OSSF Inspection Sheet

Permit#: **119024**

Address: **1475 Bonnyview**

**AEROBIC TREATMENT
DRIP TUBING SYSTEM
FOR:
LOT 889, BONNEYVIEW DR.
CANYON LAKE FOREST, UNIT 2**

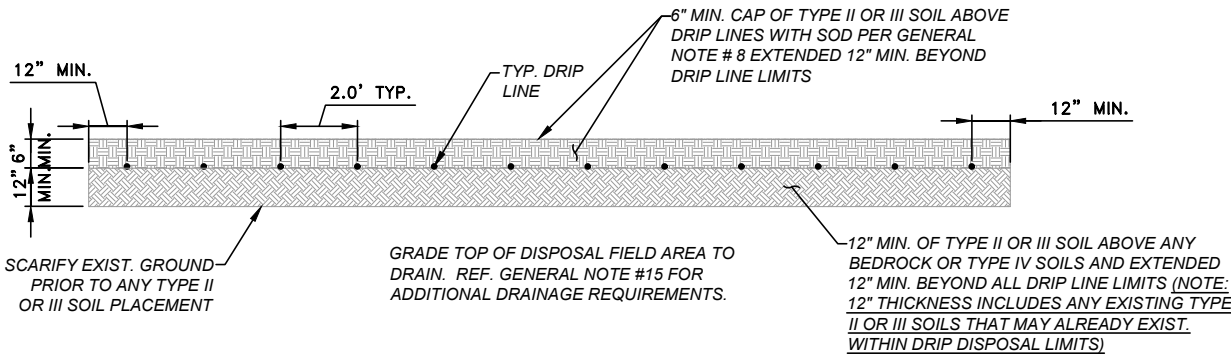
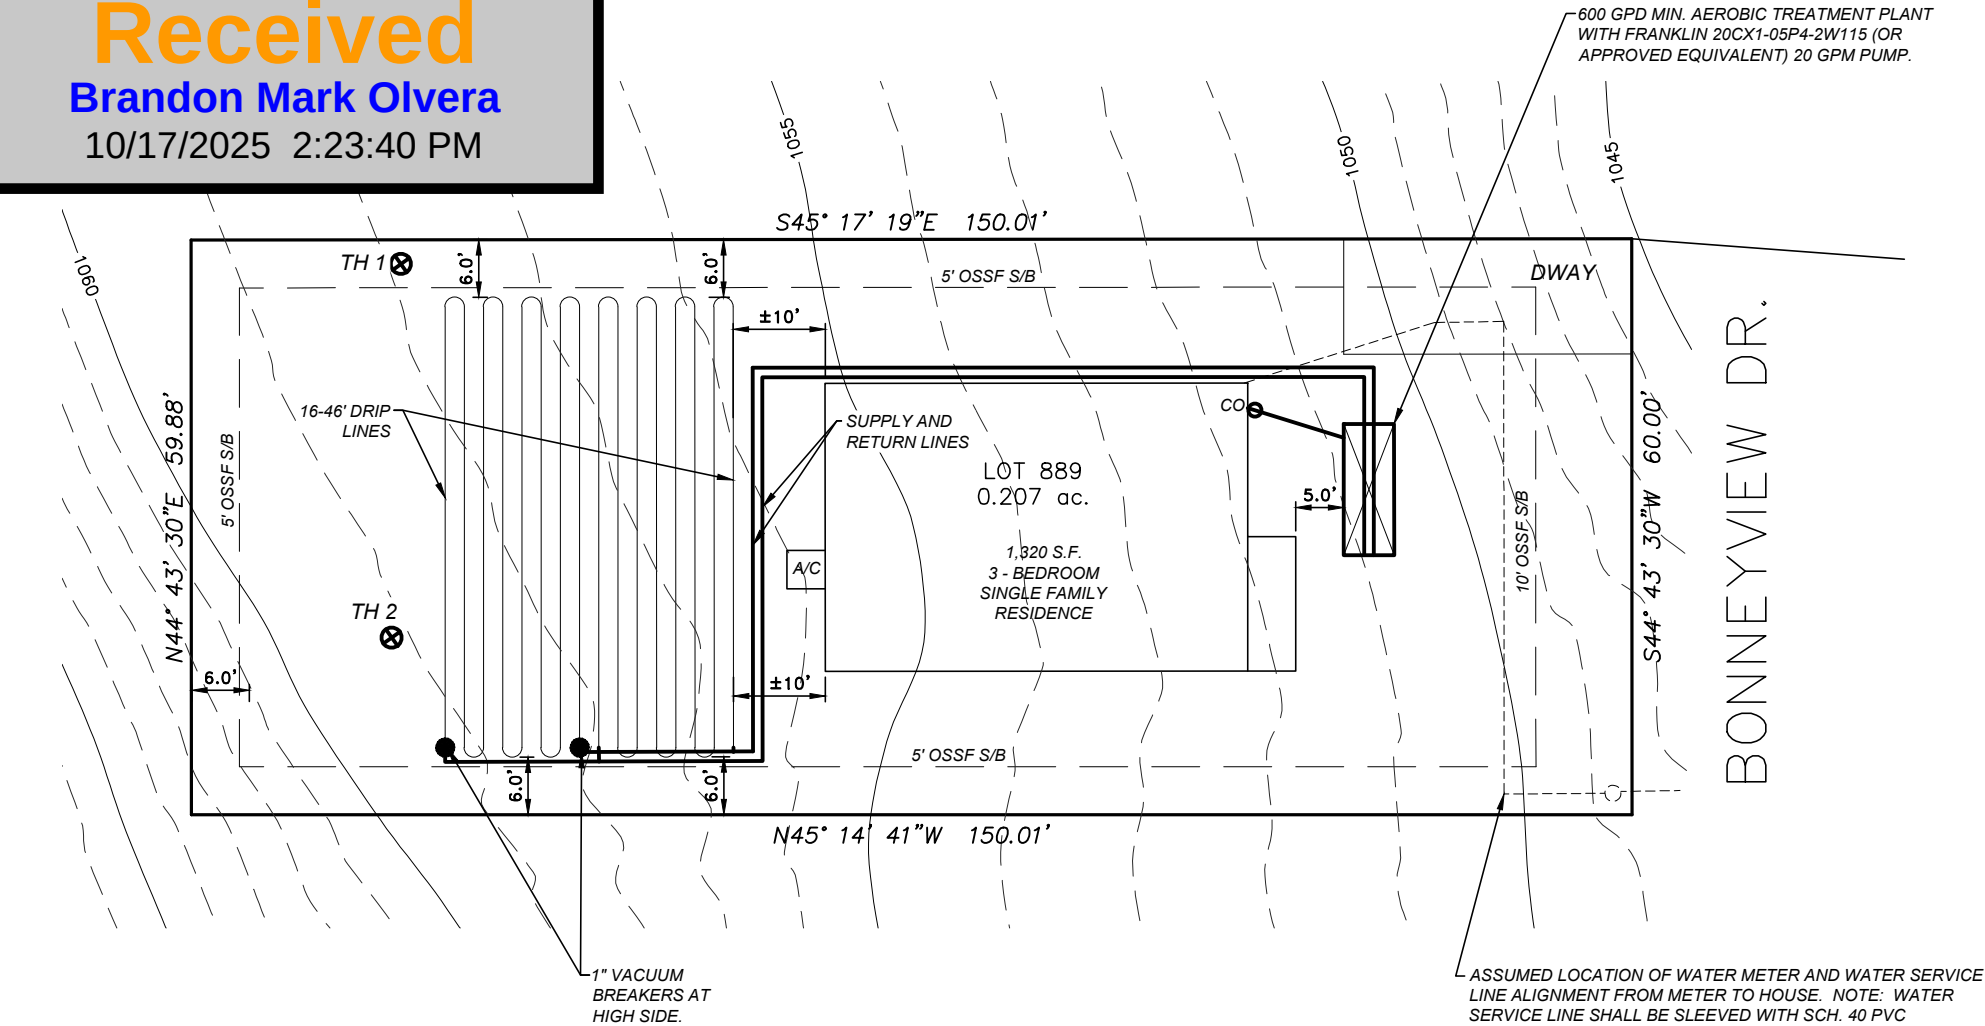
Inspector Notes: **10/24/25 CA: No tightline or tee tank level no leaks leave connection exposed**

10/29/25 CA: Operational verify 35 psi regulator on next inspection. Leave waterline exposed to verify sleeving field to design cover

11/3/25CH: 35 psi regulator installed, operational, water line sleeved per design, covered
